DONCASTER SHEFFIELD AIRPORT AIRSPACE CHANGE PROPOSAL

ACP-2024-039

Stage 1 Design Principle Submission Document

Appendix A Stakeholder Engagement Correspondence & Material

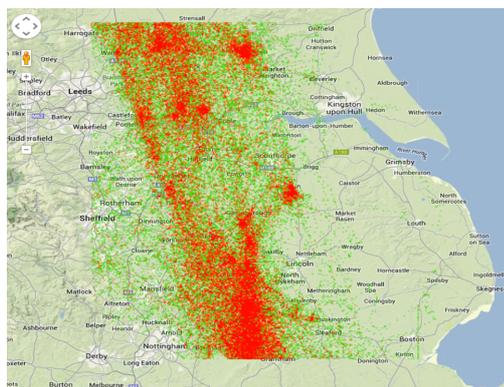
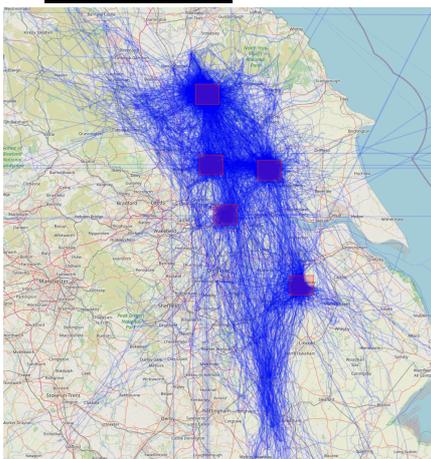
I have attached three "heatmaps" that show the gliding activity pre and post the introduction of the previous DSA CAS and which clearly illustrate the funnelling to the east and west of DSA that resulted from the CAS being implemented. These show glider flights and only part of the picture as the broader GA community was also forced into these narrow, and in the case of the western side of DSA shallow corridors increasing MAC risk significantly. Evidence of that is clear from the comments in the Post Implementation Review of the original CAS. The third heatmap shows flights following the closure of the airport and clearly re-emphasises the problem.

To clarify the gliding modus operandi, in the vicinity of the local clubs (of which there are four near DSA) gliders will be local soaring close to the airfield (within 10k) at heights from surface to the maximum available. Usually that will be up to 4000' or 5000' but could, when conditions allow be up to FL195. Cross-country flights (the majority of those on the heatmaps - which are taken from the BGA ladder - not all flights are recorded on the ladder) will typically be flown between 2000' and 6000' (for flights in thermic conditions) but again could be up to FL195 (or above in mountain wave where conditions, airspace and the AIP allow us to).

Our Final Design Principles (amends in purple)

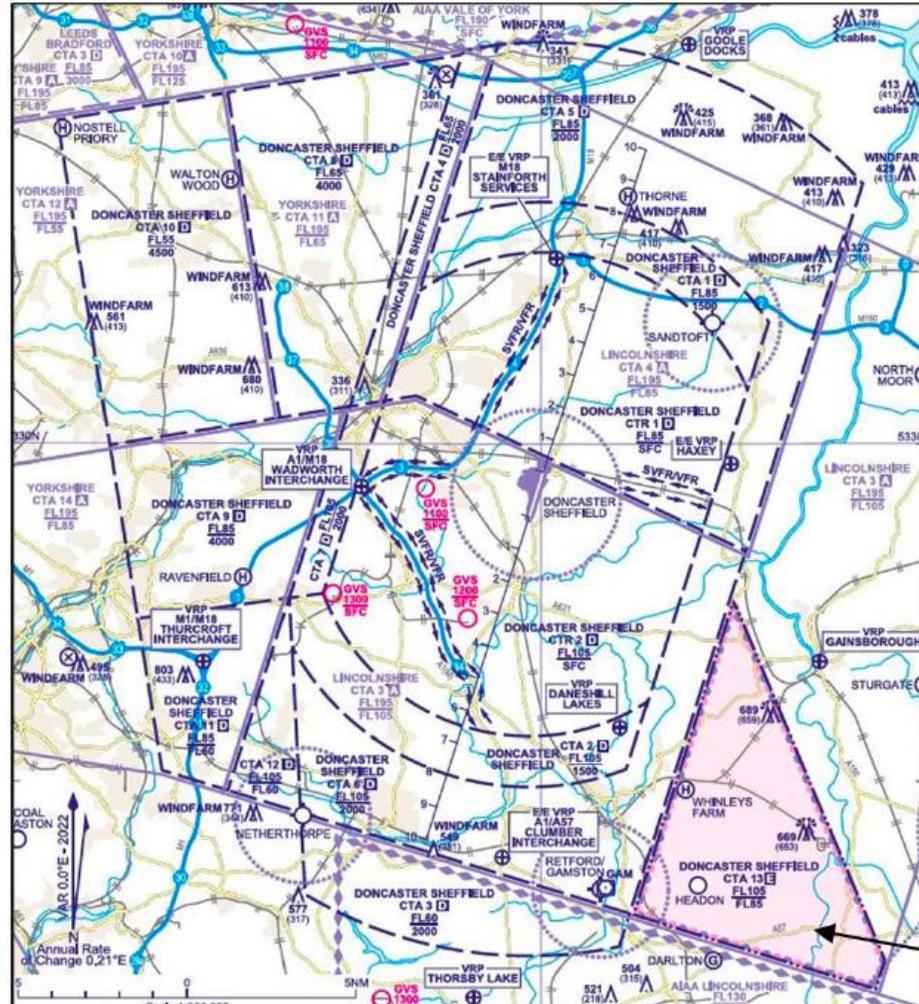
Summary of Feedback	CDC Response
Consider adding a principle on community impact and engagement, ensuring transparency and mitigation of local concerns regarding noise and air quality	This is associated with the process, rather than with the actual design of the airspace and has not led to a change in the design principles as we can't evaluate a design against this principle.
Include a principle on future-proofing to accommodate NATS regional airspace changes anticipated from 2030 onwards.	We consider this to be captured within DP4
Any airspace structure(s) arising from the ACP should be of the minimum size and lowest classification needed to achieve its aims.	This is already captured within extant CAA policy (DP2), but an additional DP (DP6) has now been added for clarification.
Any airspace structure(s) arising from this ACP should minimise disruption and maximise accessibility for other airspace users both inside the proposed airspace and around it.	This is already captured within DP2 but it has also been incorporated into the new DP6.

Airspace dimensions must be proportionate to actual realistic traffic levels forecast for the first 5 years of operation, not any theoretical capacity or outdated 2008 forecasts.	Dimensions and size of CAS is captured in DP4 and the new DP6. CAP1616 requires sponsors to forecasts to 10 years after implementation. We will not use 2008 forecasts.
The design must prioritise 'access by geometry' (minimizing lateral footprints and maximizing the base altitudes of controlled airspace sectors) rather than 'access by equipment' to ensure the continued safety and freedom of non-radio and non-transponder equipped sport aviation.	Captured within the new DP6
Some disagreement with the principle to not modify DSA's previous NPRs unless required for safety or airspace integration purposes.	CDC has not changed this design principle. It is acceptable for a design principle to act as a design constraint.

1. The airspace change proposal must maintain a high standard of safety and should seek to enhance current levels of safety.
2. The airspace change proposal should not be inconsistent with relevant legislation, the CAA's airspace modernisation strategy or Secretary of State and CAA's policy and guidance.

3. The airspace change proposal should deliver the Government's key environmental objectives with respect to air navigation as set out in the Government's Air Navigation Guidance 2017.

4. The airspace change proposal should consider the impacts on air navigation service providers and other aviation stakeholders such as nearby airport operators **and other airspace users**.

5. The airspace change proposal should not modify DSA's previous NPRs unless required for safety or airspace integration purposes.
6. **Any airspace structure(s) should be of the minimum size and lowest classification needed to achieve its aims to minimise disruption to, and maximise integration with, other airspace users.**

Option 2 – Refinement of Option 1, based on stakeholder feedback or to align with latest CAA policy

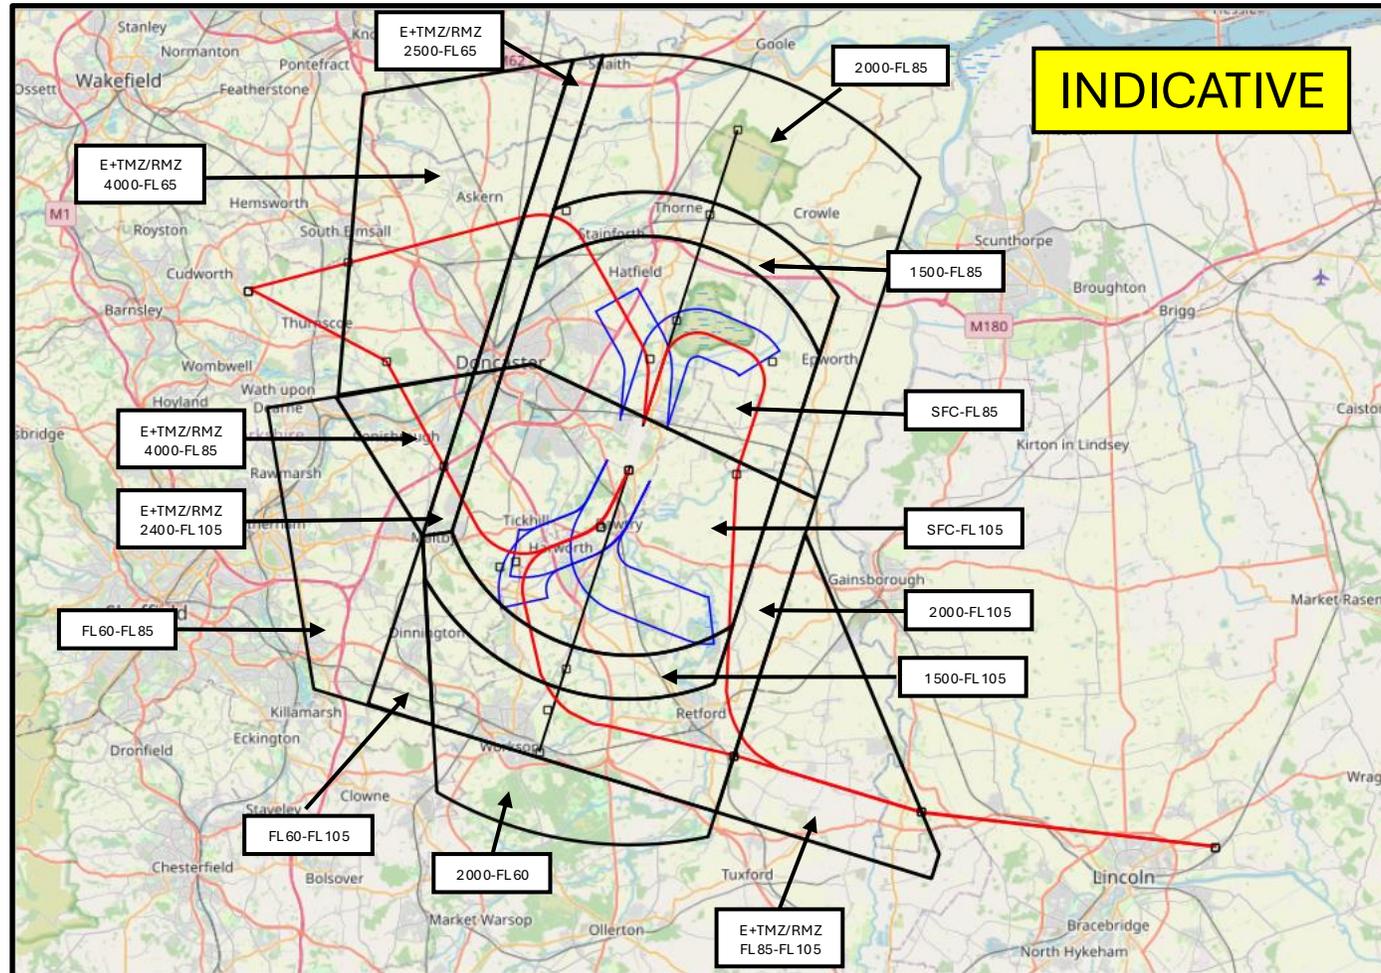
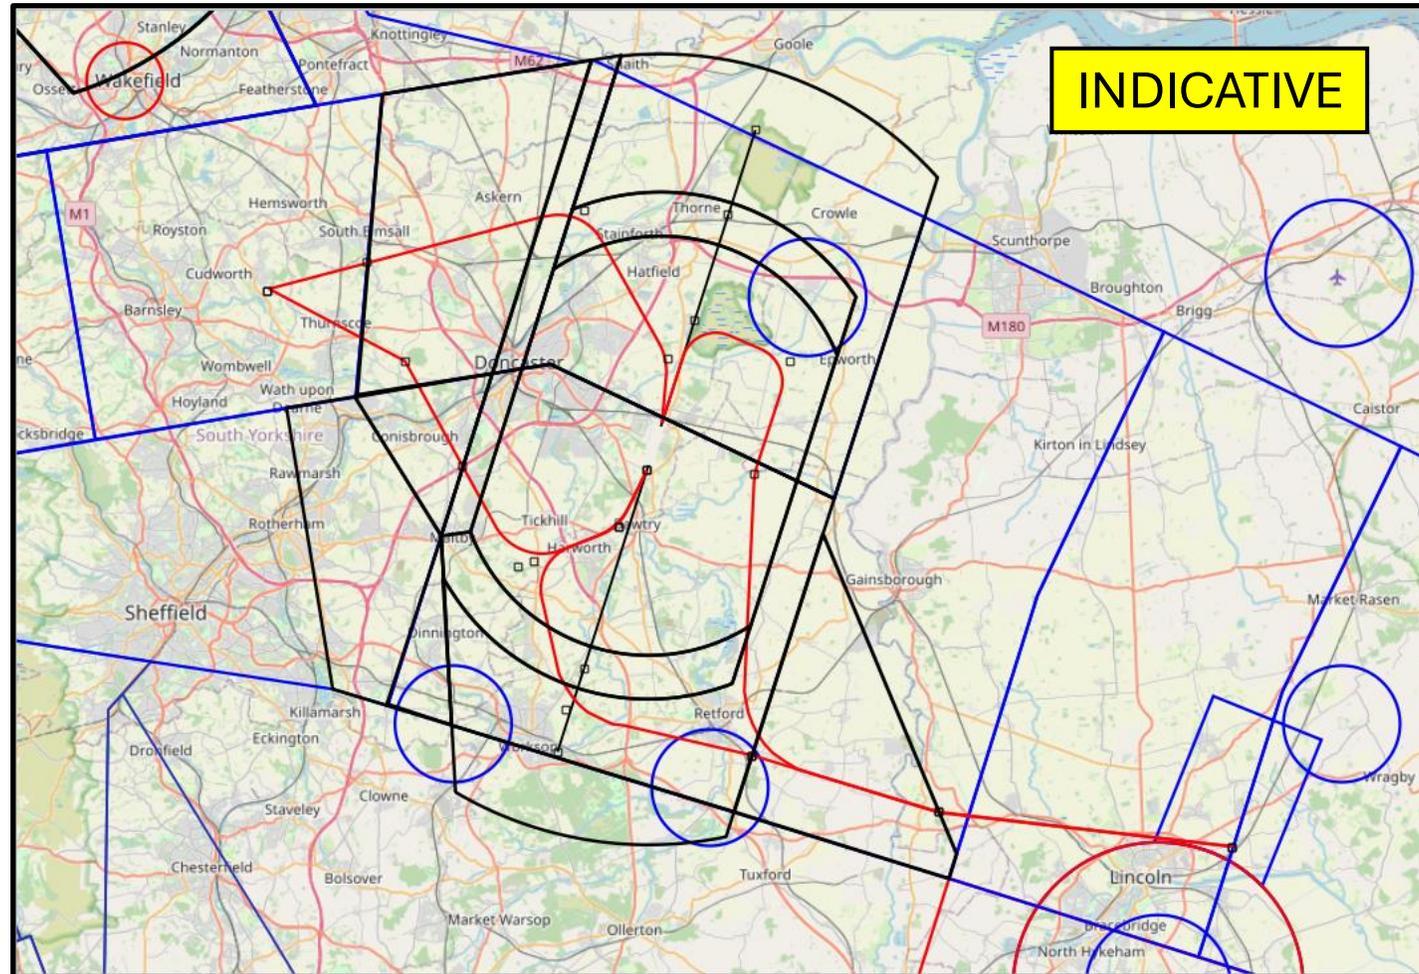
Summary of Feedback	CDC Response
Some stakeholders argued that DSA shouldn't have any Controlled Airspace at all and that it's not required for commercial operations and/or it's not justified for the forecast number of movements at the airport. They requested we include an option for no Controlled Airspace.	The challenge over the need for Controlled Airspace is understandable. Our Stage 2 submission to the CAA also considers an option where DSA operate commercial flights in Class G (uncontrolled) airspace. This is called Option 0.
Some stakeholders suggested refinements to the option we shared.	We have developed an option with modifications to the design we shared. This is called Option 2.
Some stakeholders suggested CDC develop an additional option with a new, more innovative PBN procedure design to try and reduce the volume of Controlled Airspace.	We have now developed an option with a different procedure (route) design, with an associated reduction in the volume of Controlled Airspace. This is called Option 3.

- These additional options requested by our stakeholders are presented on the following slides together with the single option we previously shared.
- **Please note that the fidelity of the design options and the detail of analysis increases as the process progresses. Therefore, stakeholders can expect further changes to the Stage 2 options taken forwards into Stages 3 and 4 of the process, as we seek to evolve a solution that best balances the competing stakeholder requirements, in accordance with further stakeholder feedback.**
